STAFF REPORT CORRECTED 7-26-84  
CITY PLANNING COMMISSION

- APPLICATION:
- A. Negative Declaration
  - B. Amend Sutterville Heights Community Plan from Light Density Residential to Shopping Commercial;
  - C. Plan Review for a portion of a 23,000+ sq. ft. retail commercial building;
  - D. Lot Line Merger to create one parcel.

PROPOSAL: The applicant is requesting the necessary entitlements to merge three parcels into one parcel and develop a 23,760+ square foot commercial shopping area to be known as Pacific Village.

APPLC. NO. P84- 245.

**EXHIBIT D**

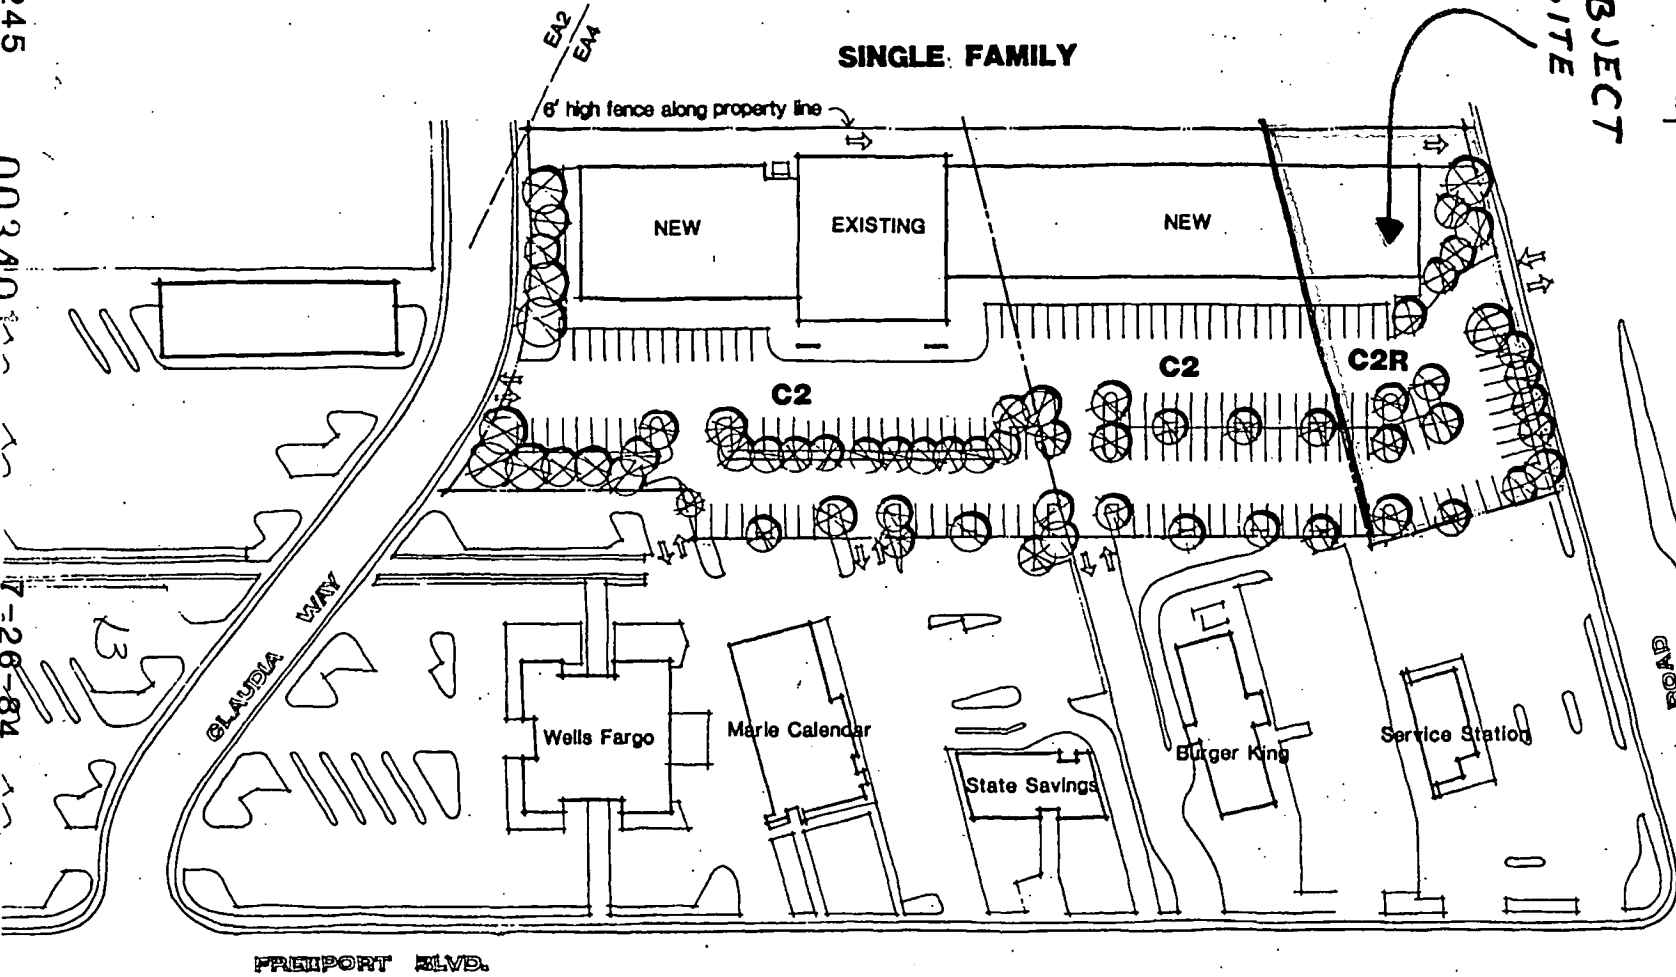
3. The applicant's plans indicate a single story building consisting of wood and concrete with a metal roof. A six-foot high masonry wall will separate the site from the adjacent residences to the west. A 15 foot alley will be located to the rear of the proposed building and adjacent to the residential area. The alley will be used for and by delivery trucks.

There are no major objections to the proposed plans; however, some minor additions should be made, these include:

- a. Location and construction of trash enclosures should be in accordance with the criteria outlined in Exhibit F.
  - b. Landscape and irrigation plans should be submitted for review and approval.
  - c. A sign program should be submitted for review and approval.
4. The project was reviewed by the offices of the Public Works Director, Traffic Engineer and Building Department. The following comments were received:

- a. East driveway on Fruitridge Road must line up with existing driveway and must have 50-foot minimum 90 degree approach to street;
- b. West driveway (alley) must be at least 10 feet from property line, plus three feet of 'curb flare' on both streets;
- c. Claudia Way driveway must be 90 degrees (or radial) to center line. Eliminate first two stalls on east;
- d. Clarify what happens to existing driveway at east property line on Claudia Way.

- 1. The applicant shall comply with requirements of the City Traffic Engineer.
- 2. The applicant shall submit a detailed landscape, irrigation and shading plan to the Planning Director for review and approval prior to issuance of a building permit.

- 3. The applicant shall construct a six-foot high solid decorative masonry wall along the west property line.
- 4. The applicant shall comply with the design criteria for trash enclosures as outlined in Exhibit F.
